5 3D View

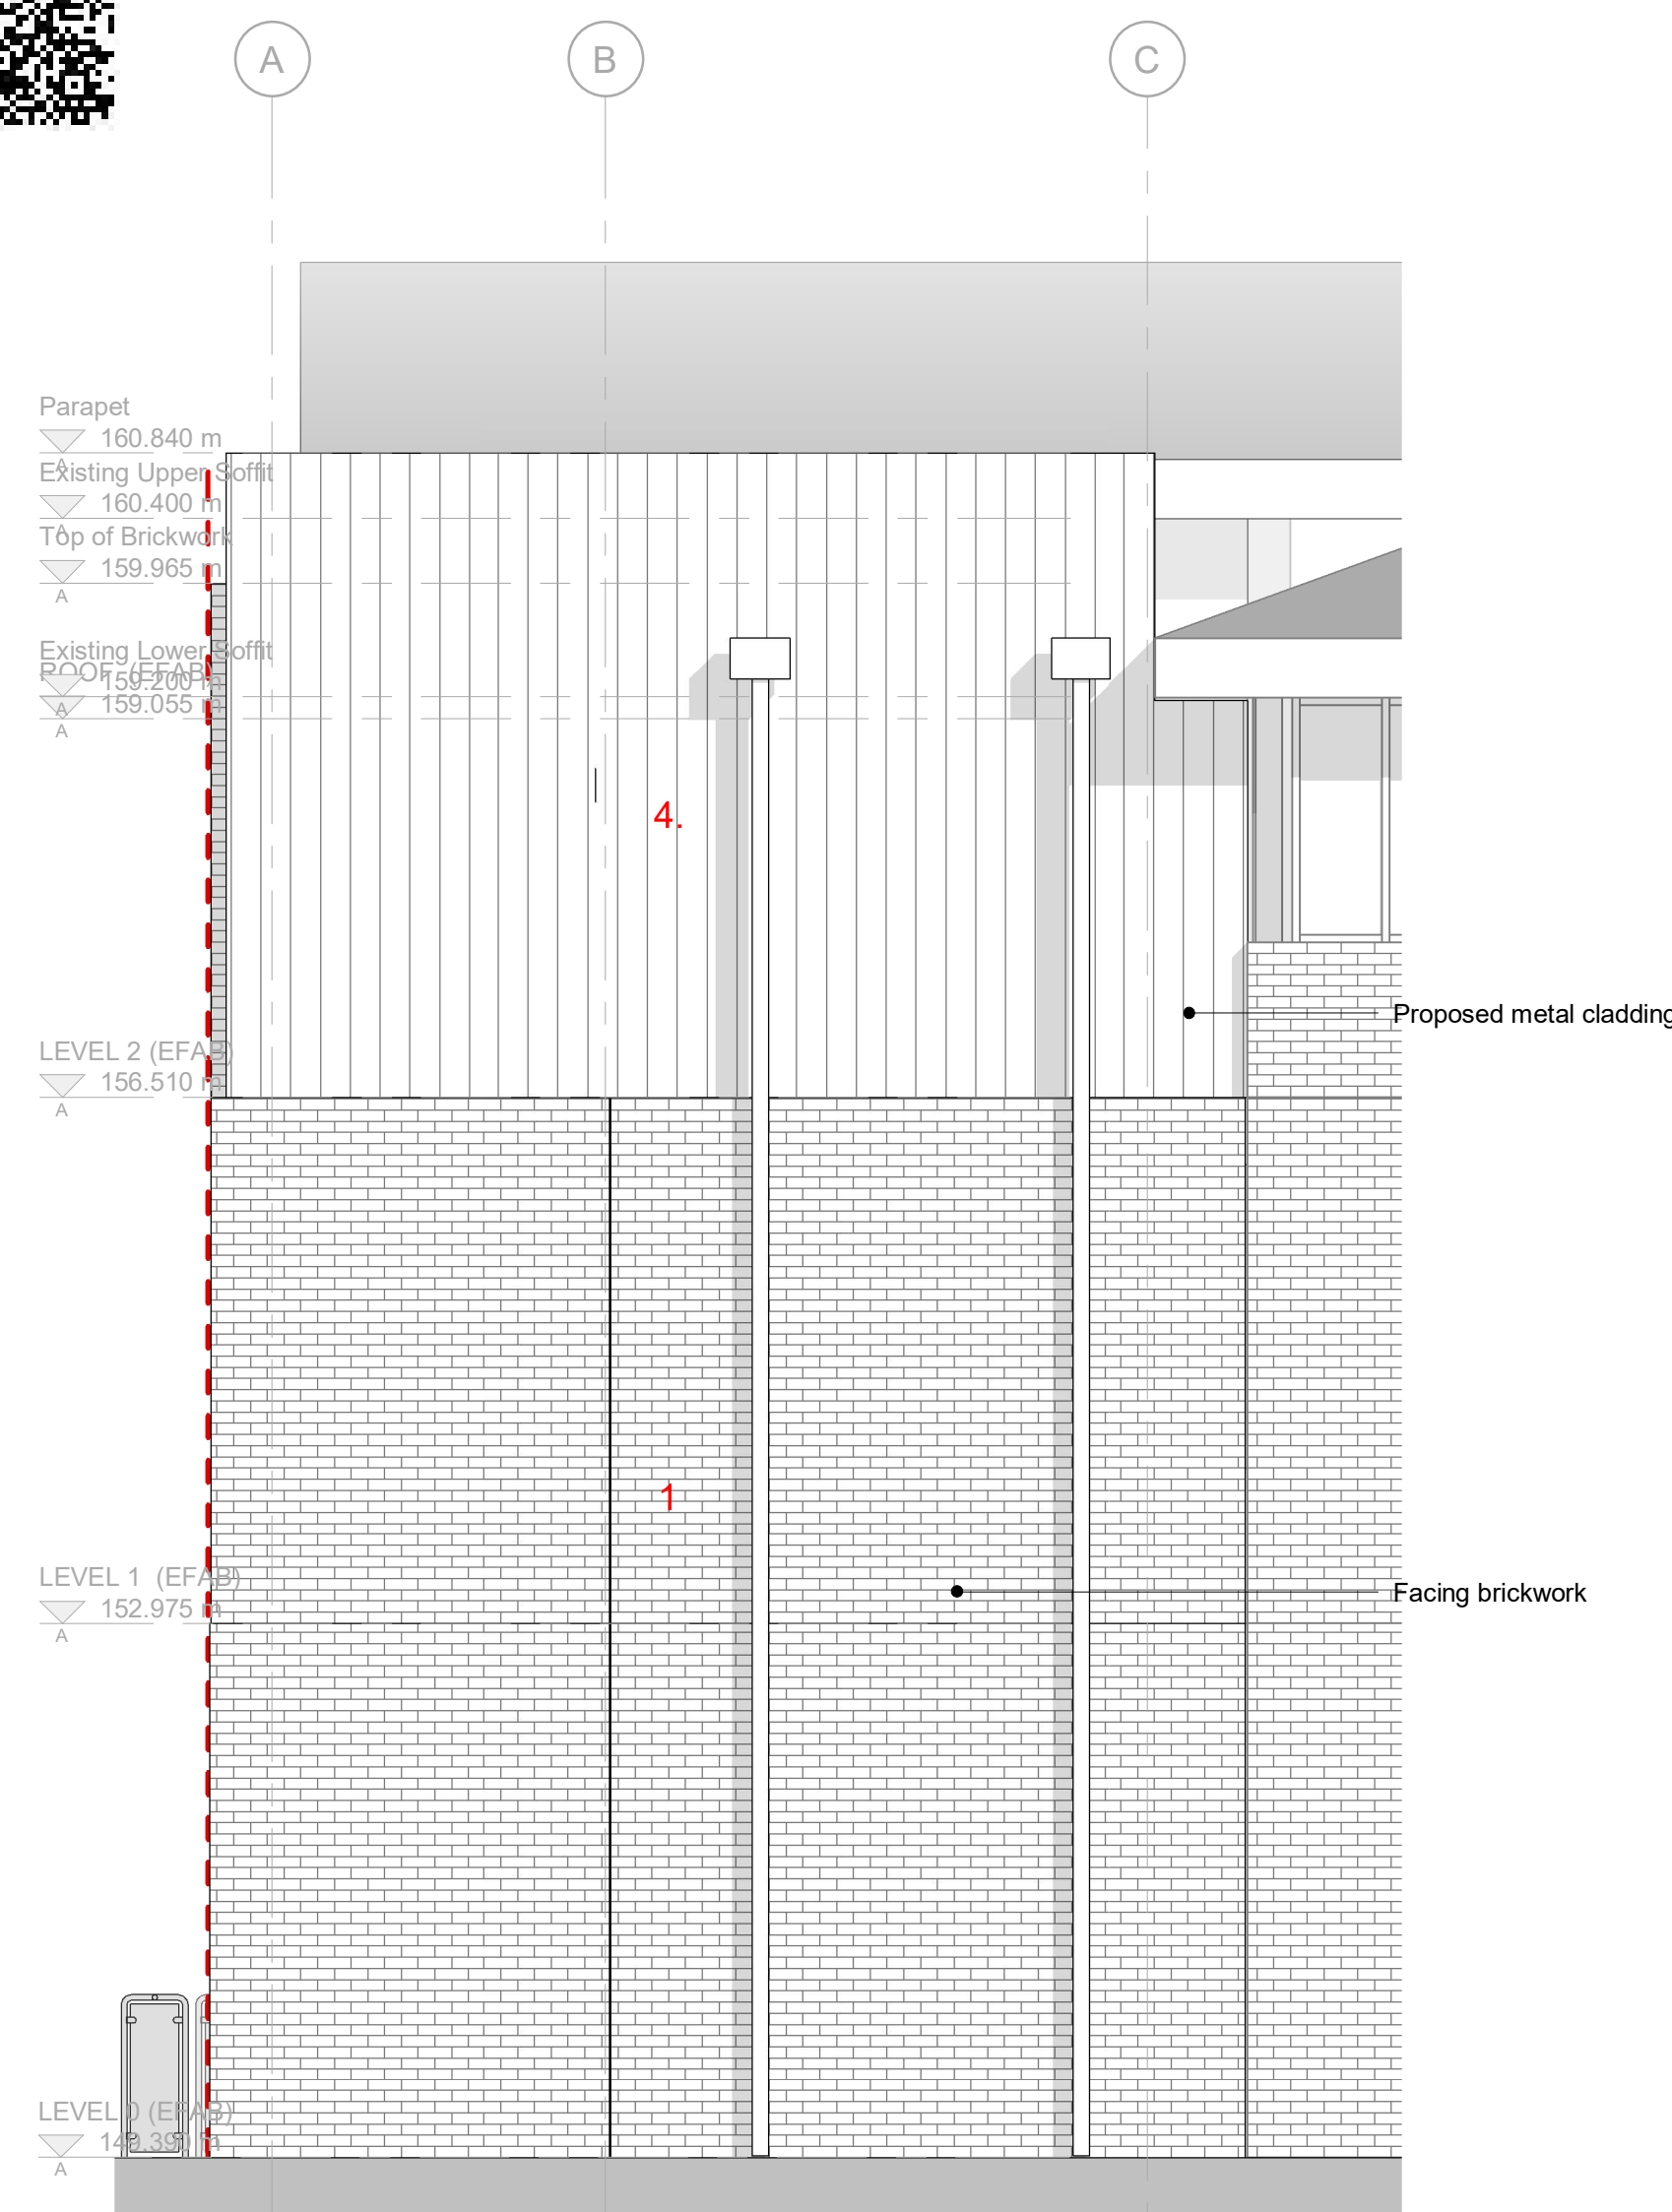
Building Door Replaced with New Window
Location Subject to Survey
